Plan Commission Staff Report
Meeting Date: October 17, 2023

PETITION: PC-23-016, Culver's Restaurant Re-plat of a Primary Plat & Subdivision Control Waiver

REQUEST: Petitioner requests approval of a Primary Plat for two (2) lots on approximately 3 acres, as well as a Subdivision Control Ordinance waiver for dedication of right-of-way.

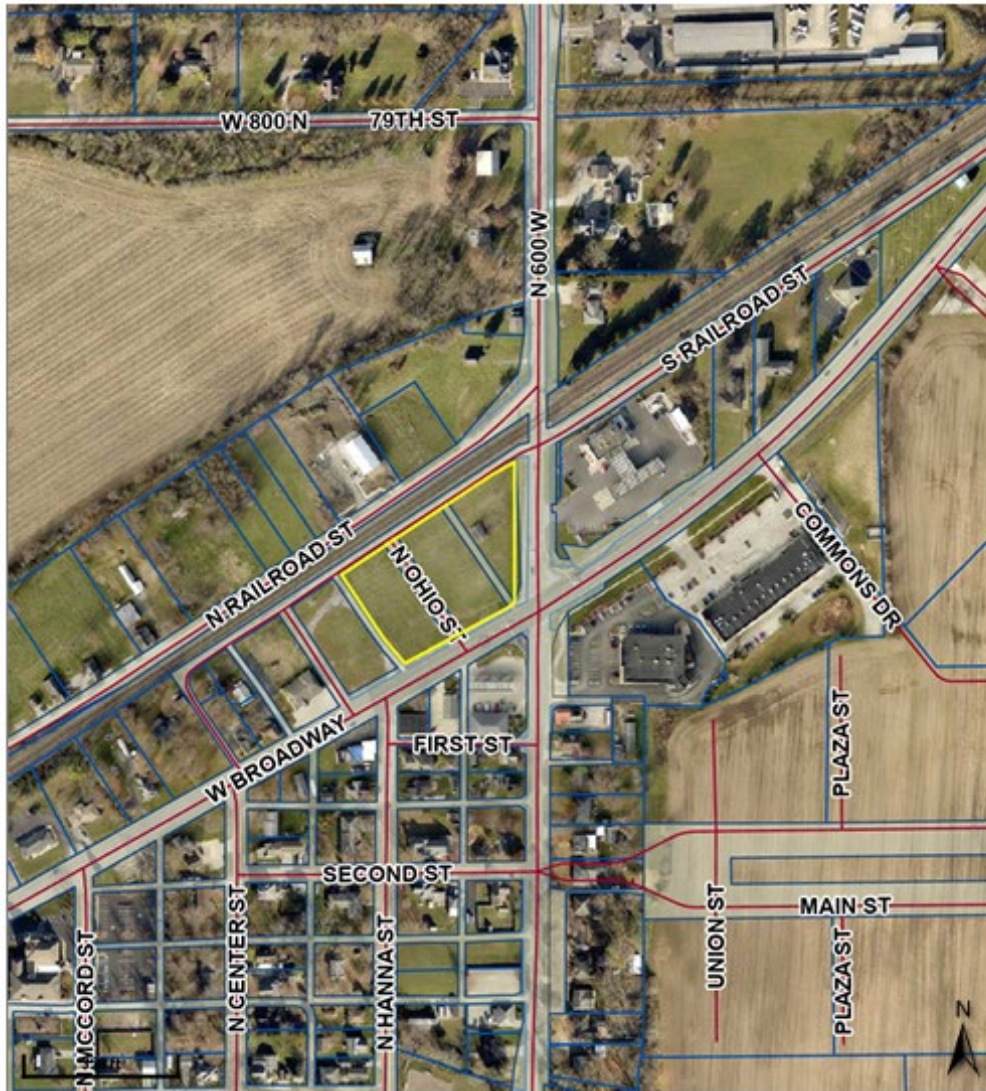
1. The existing right-of-way for St. Railroad Street needs to be added to the plat.

2. Staff has requested adjustments to the “to be vacated” portions of right-of-way for Ohio Street and the two (2) alleys. Staff can provide further clarification on the requested adjustments if needed at the meeting.
